LIVINGSTONE LANE SUBDIVISION

APPLICATION NUMBER 5 DATE October 19, 2006
APPLICANT Livingstone Lane Subdivision
REQUEST Subdivision

DETAIL SITE PLAN

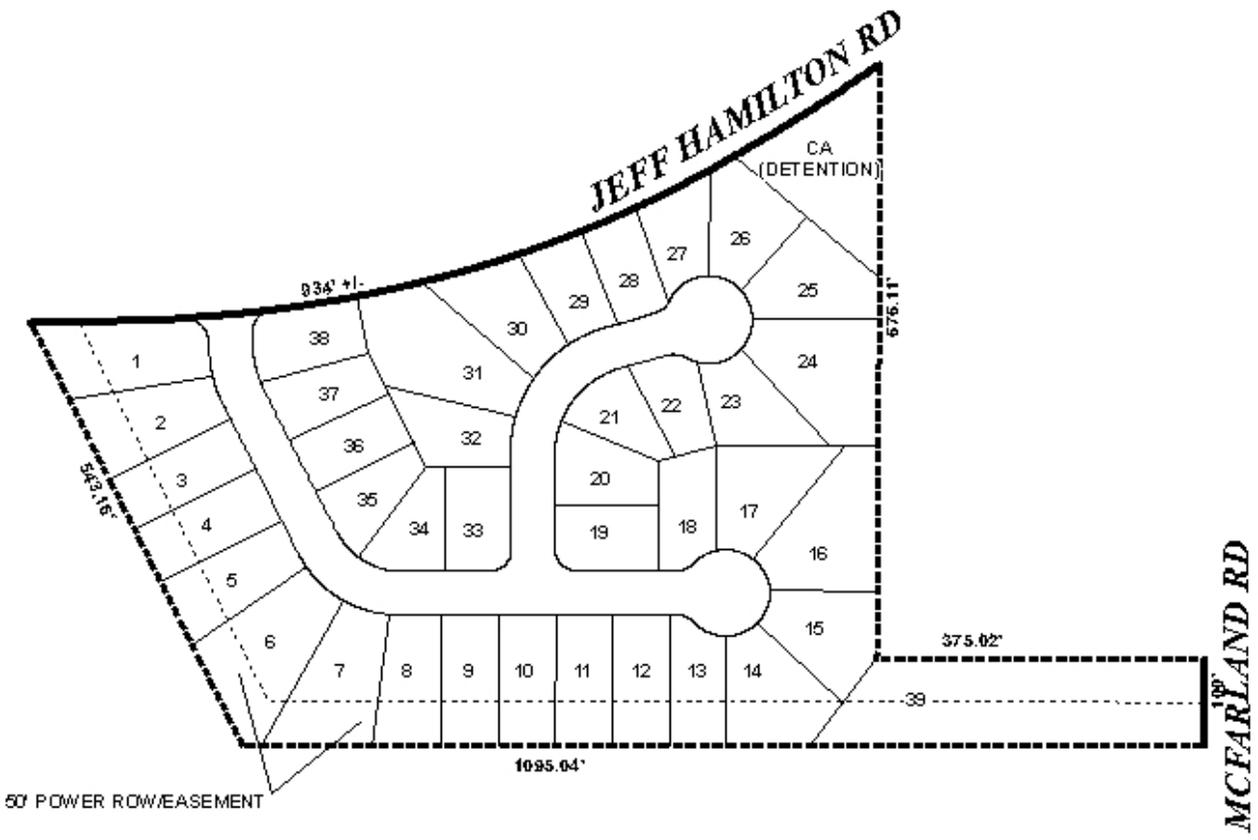
As designed, the proposed subdivision will have 9 lots with frontage on either Jeff Hamilton Road or McFarland Road. Eight of the proposed lots, lots 1, 26-31 and 38, have a double frontage condition (they also have frontage on a proposed street within the subdivision), thus they should be denied direct access to Jeff Hamilton Road. Proposed lot 39 only has frontage on McFarland Road, a proposed major street, thus it should be limited to one curb-cut onto McFarland Road. The size, design and location of all curb-cuts must be approved by Mobile County Engineering.

A common area detention basin is proposed for the subdivision near the Northeast corner of the site. Review of contour information, which should be depicted on the plat, indicates that the proposed location is at the lowest point within the site. The plat should be revised to depict contours, as required in Section IV.2.b. of the Subdivision Regulations, and a note should be placed on the final plat, if approved, stating that maintenance of the detention basin common area, and any other common areas, is the responsibility of the subdivision's property owners. It should also be pointed out that access to the detention basin appears to only be possible from Jeff Hamilton Road.

The 25-foot minimum building setback line, required in Section V.D.9., is not shown for the subdivision, but would be required on the final plat, if approved.

A 50-foot wide Alabama Power right-of-way easement occurs along the West and South sides of the site. A note should be placed on the plat stating that no permanent structures such as buildings or pools may be placed within the easement.

Based upon the preceding, the application is recommended for Tentative Approval, subject to the following conditions: 1) placement of a note on the final plat denying direct access to Jeff Hamilton Road for lots 1, 26-31 and 38; 2) placement of a note on the final plat limiting lot 39 to one curb-cut onto McFarland Road, with the size, design and location to be approved by Mobile County Engineering; 3) revision of the plat to depict the contour information required by the Subdivision Regulations; 4) labeling of all common and detention areas, and placement of a note on the plat stating that maintenance of the detention basin and common areas is the responsibility of the subdivision's property owners; 5) provision of a certification letter from a licensed engineer to the Planning Section of Urban Development, certifying that the stormwater detention, drainage facilities, and release rate comply with the City of Mobile stormwater and flood control ordinances, prior to the signing and recording of the final plat; 6) depiction of the 25-foot minimum building setback line from all road frontages; 7) placement of a note on the final plat stating that no permanent structures such as buildings or pools may be placed within the Alabama Power easement; 8) revision of the plat to label each lot in square feet, or provision of a table on the plat depicting the same information; and 9) placement of a note on the plat stating that any lots which are developed commercially and adjoin residentially developed property must provide a buffer, in compliance with Section V.A.7. of the Subdivision Regulations.
